**HAM CR 251 0.11
 BLUE ASH RD PH 2**

CITY OF DEER PARK
 HAMILTON COUNTY

REVIEW COMPLETE

STAGE 1 SUBMITTAL - 2/14/2025

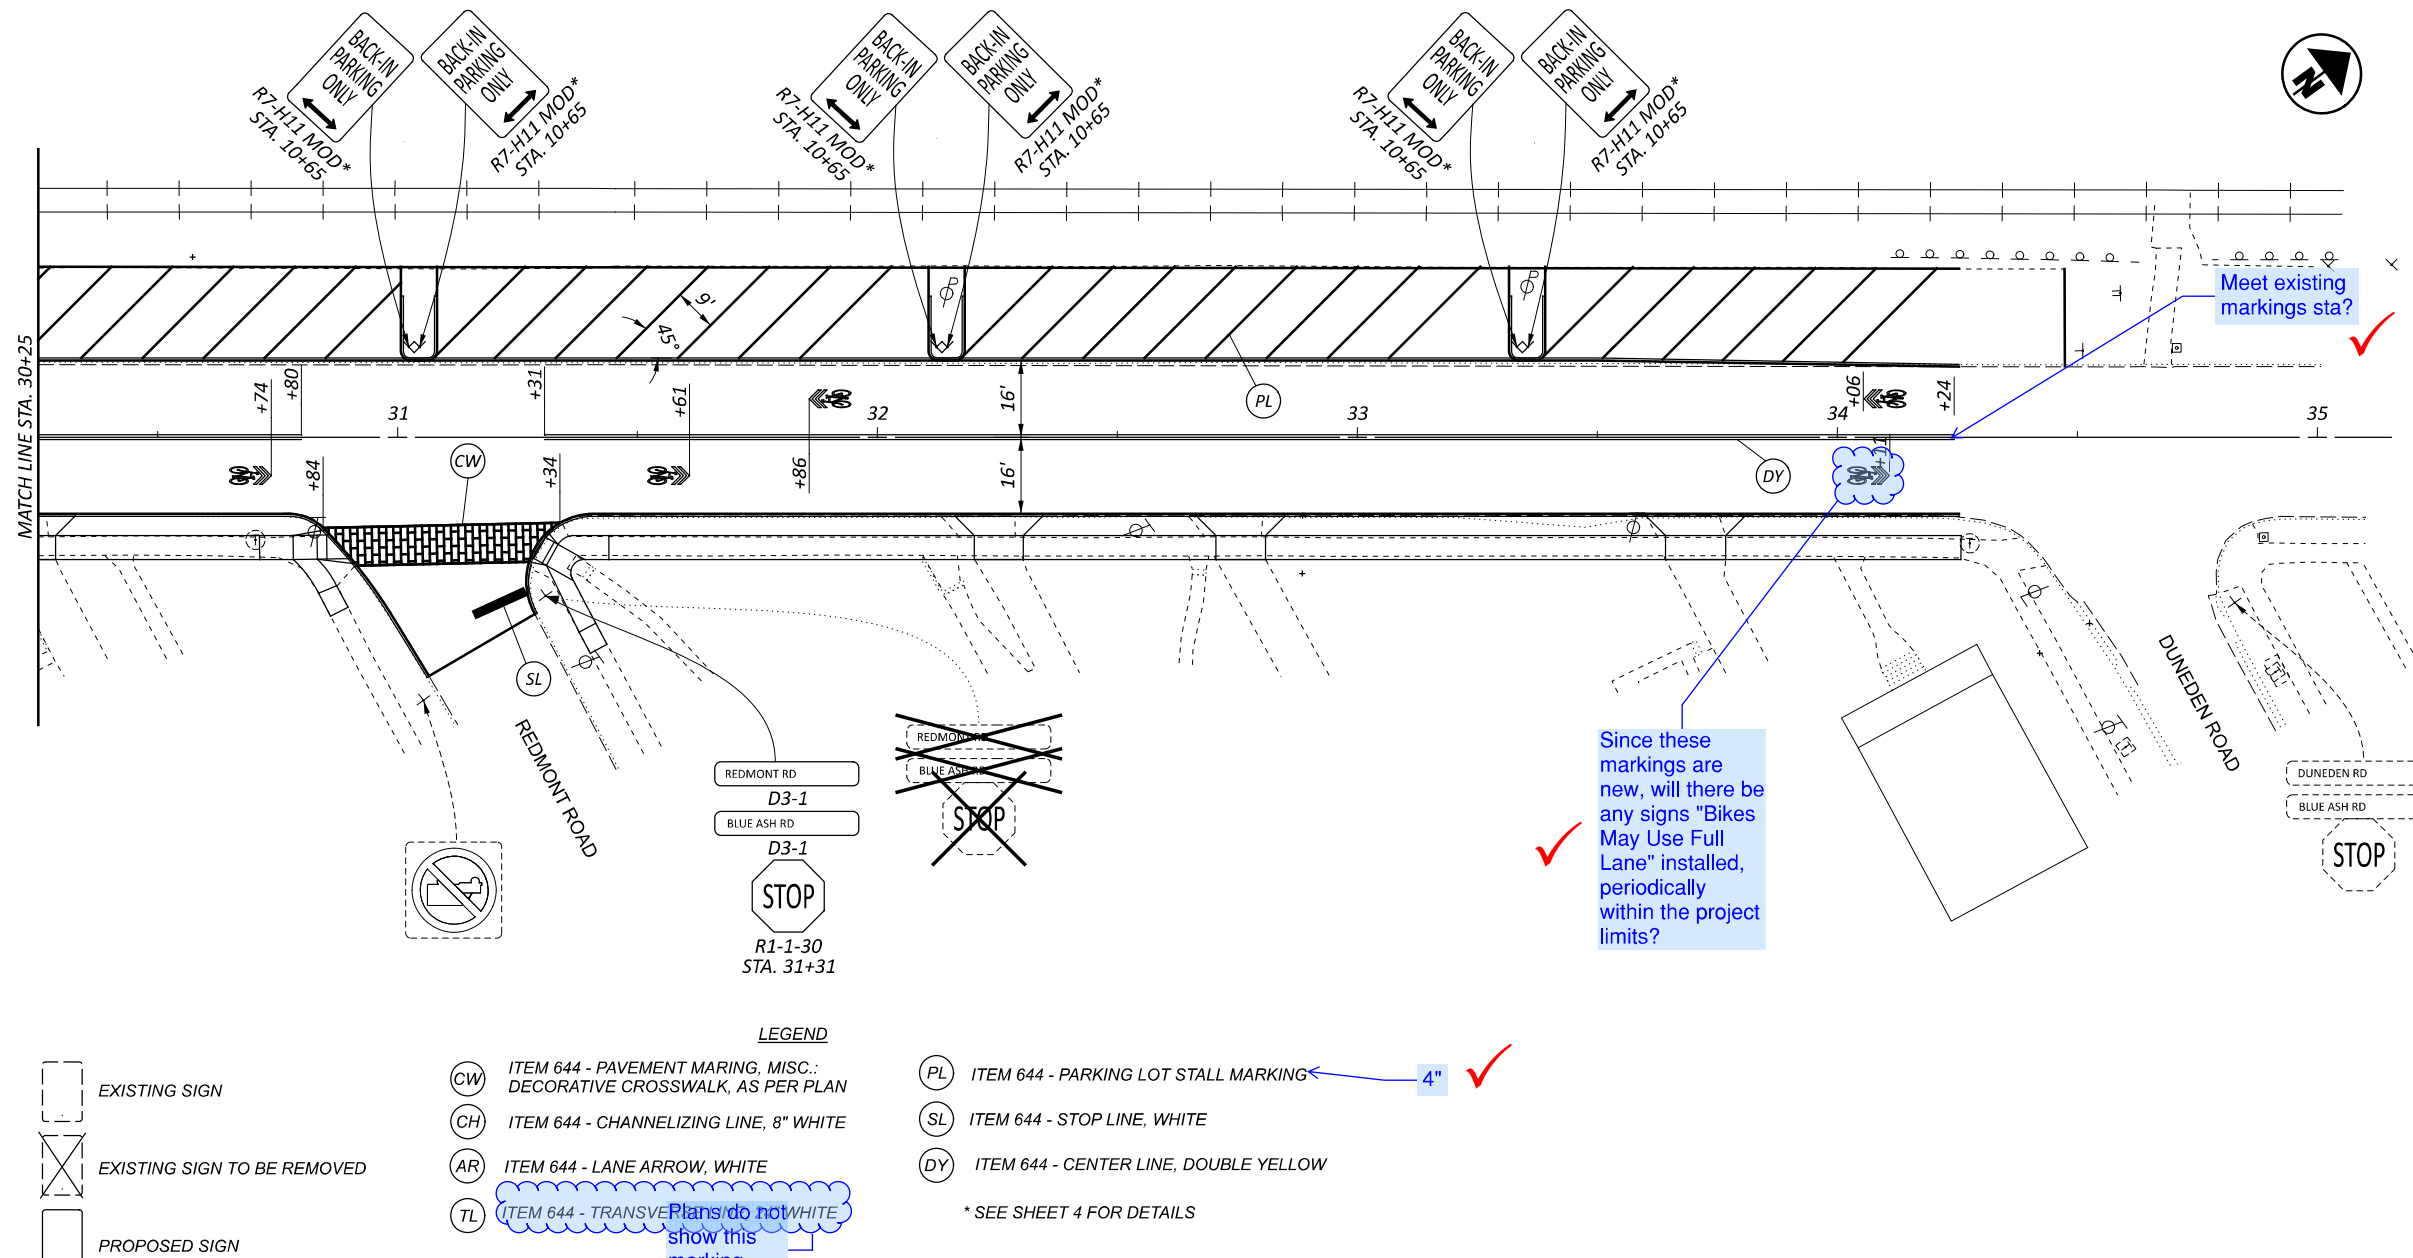
Plans do not show this marking anywhere?

Marking updated to 12" yellow.

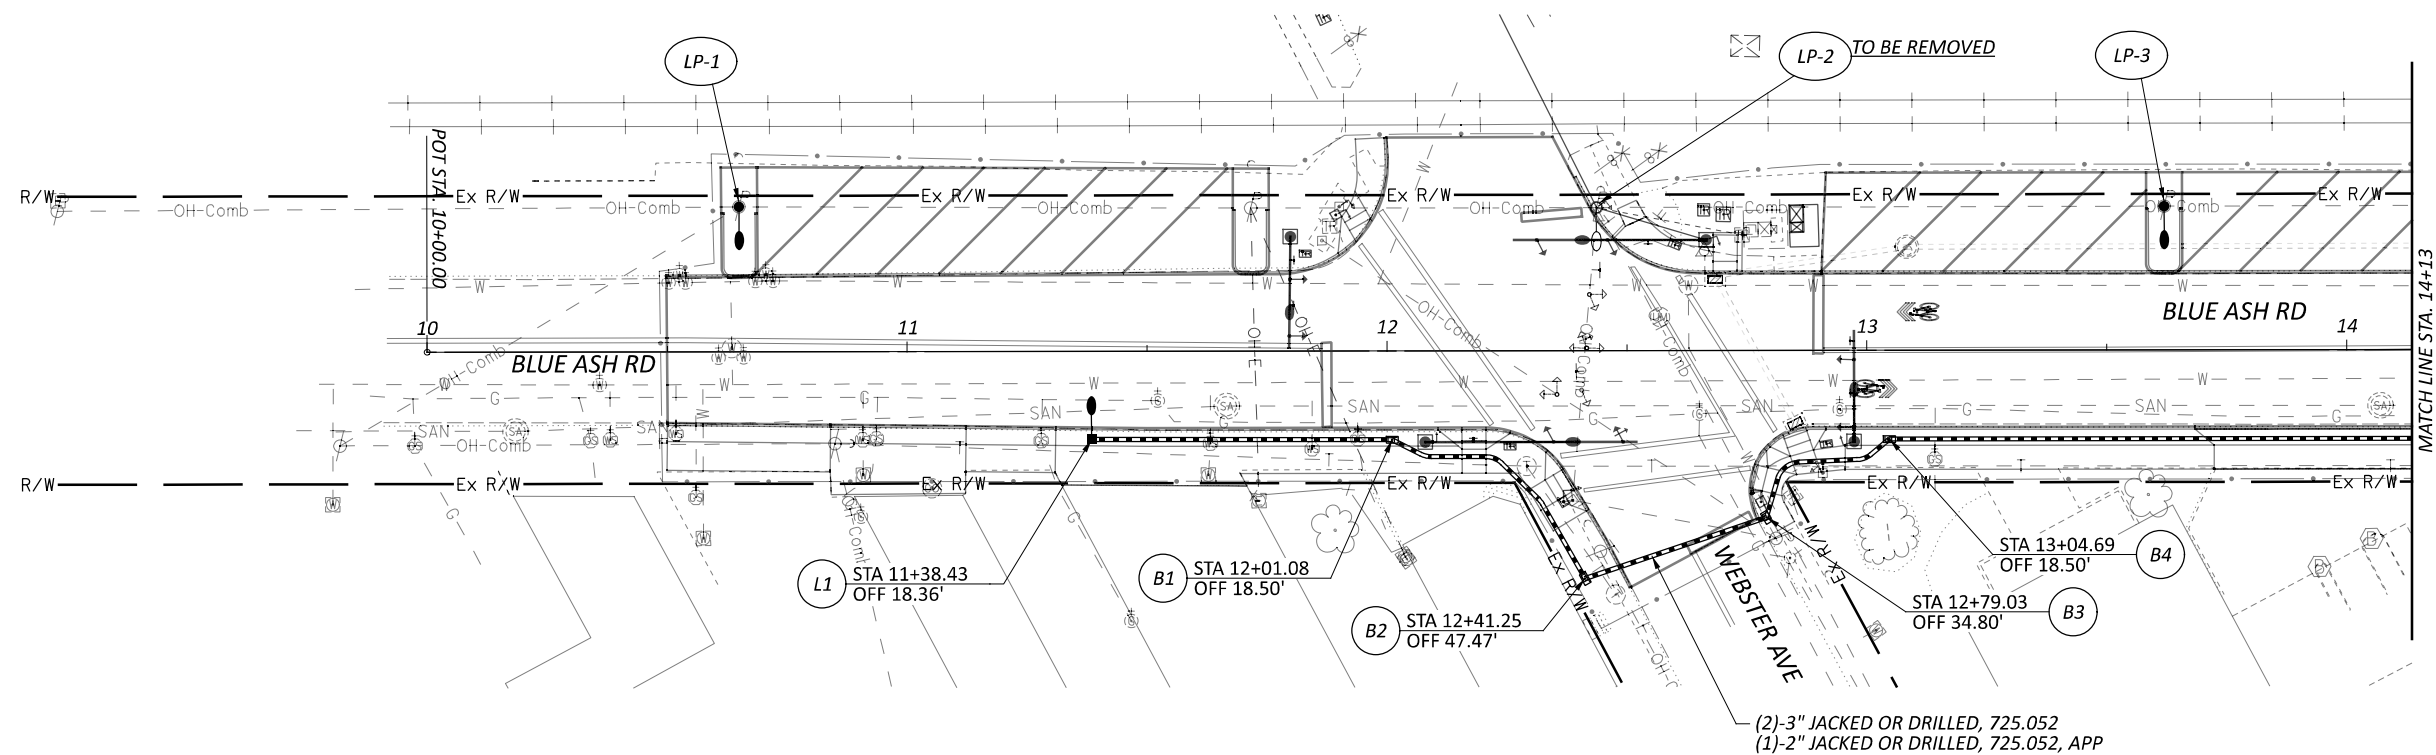
Show power service location, once known.
 Duke plans need to be prepared in conjunction with the construction plans so that Duke's cost to install is known and can be inserted into the plans for all bidders (third party billing.)

Understood - Will identify in plans once Duke provides final circuit design. Line item provided for Duke Lighting Contract.
